SUBJECT: Initial Draft of AN3308 Revision 7
Project number 5945-2023-040

INCH-POUND
AN3308
REVISION 7
DRAFT
SUPERSEDING
REVISION 6
7 June 2011

RELAY, 10 AMP, 3 PDT, SEALED,
CONNECTOR MOUNTING, CLASS O

FIGURE 1. Configurations and dimensions.

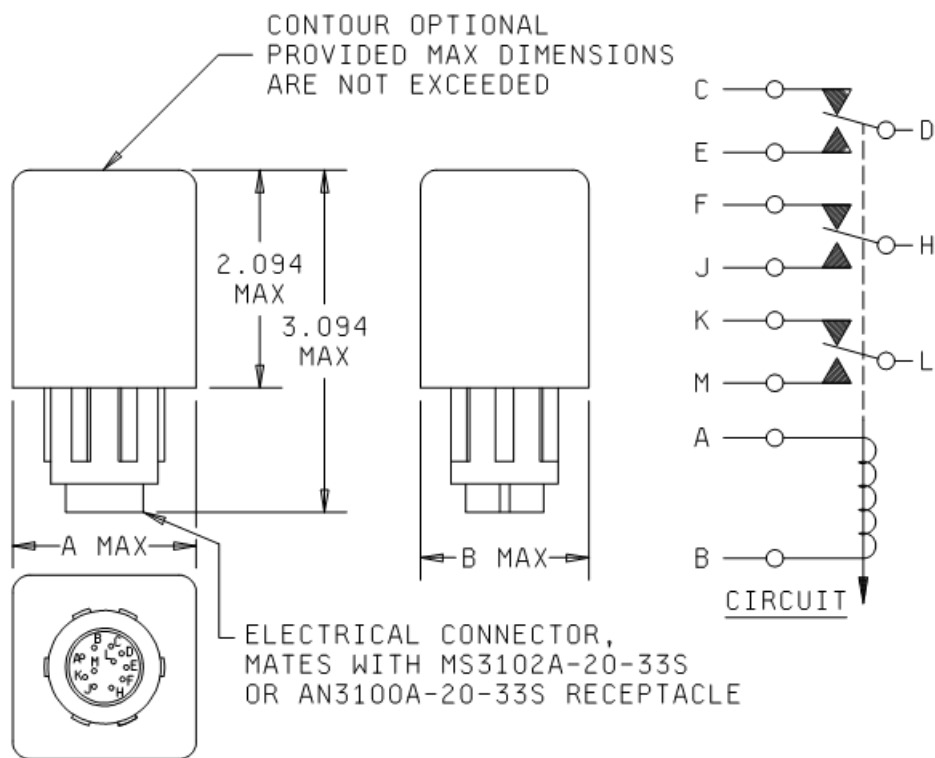
The draft of the above subject document is being sent to you for review and comments. The draft consists of the following changes: Replaced DAPS reference, changed annual reporting requirement, added distribution statement, added QR Code, adjusted table columns and rows to make them 508 compliant, and adjusted figures to make them 508 compliant
